**ADDENDUM NO. 1**

**Date: December 4, 2018**

**Re: ITB# 3090-18: Construction of Aircraft Wash Rack Facility**

# C015

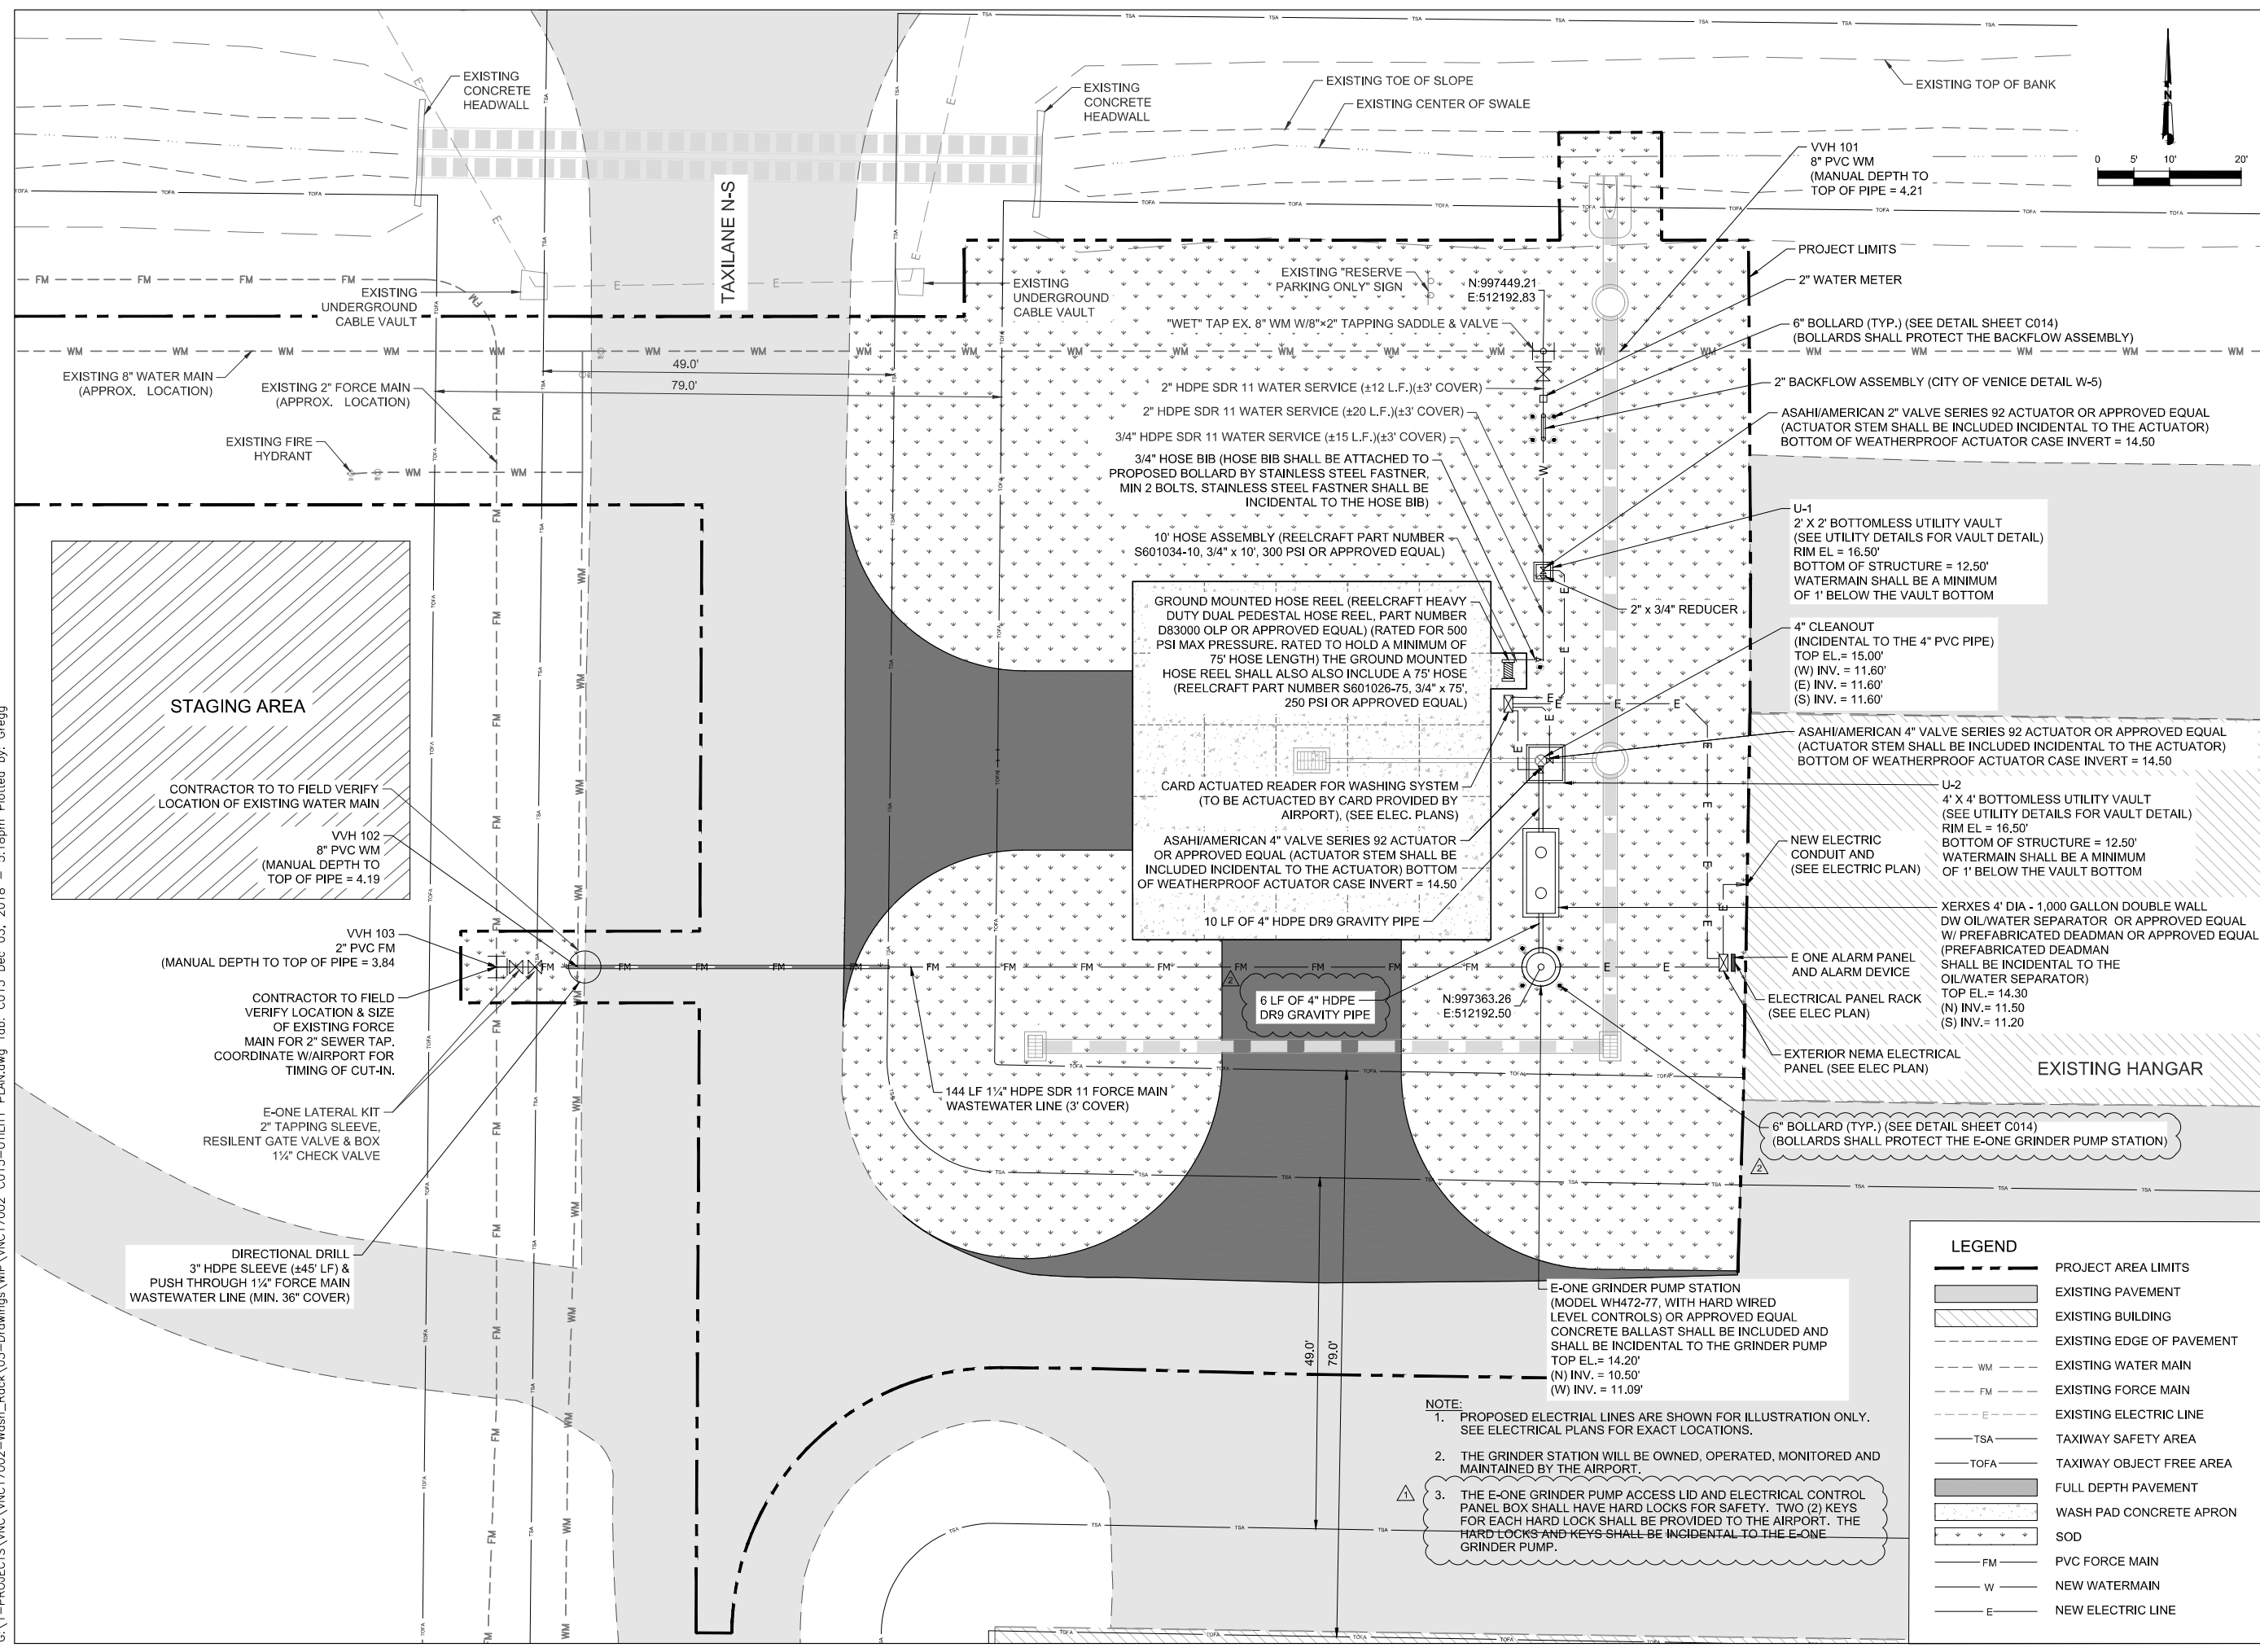
28. "Drawing C015 shows 6" pipe bollard protection @ RPZBFP device and also @ the hose reel. There is no bollard protection shown at the proposed lift station & holding tank locations. Is bollard protection going to be required for drive over protection of these areas?"

**Response: Four (4) – 6" bollards shall be provided around the grinder pump station. No bollards shall be required around the oil water separator.**

Revision Schedule		
No.	Description	Date
1	FDEP REVISIONS	11/07/2018
2	ADDENDUM #1	12/03/2018

- PROPOSED ELECTRICAL LINES ARE SHOWN FOR ILLUSTRATION ONLY. SEE ELECTRICAL PLANS FOR EXACT LOCATIONS.
- THE GRINDER STATION WILL BE OWNED, OPERATED, MONITORED AND MAINTAINED BY THE AIRPORT.
- THE E-ONE GRINDER PUMP ACCESS LID AND ELECTRICAL CONTROL PANEL BOX SHALL HAVE HARD LOCKS FOR SAFETY. TWO (2) KEYS FOR EACH HARD LOCK SHALL BE PROVIDED TO THE AIRPORT. THE HARD LOCKS AND KEYS SHALL BE INCIDENTAL TO THE E-ONE GRINDER PUMP.
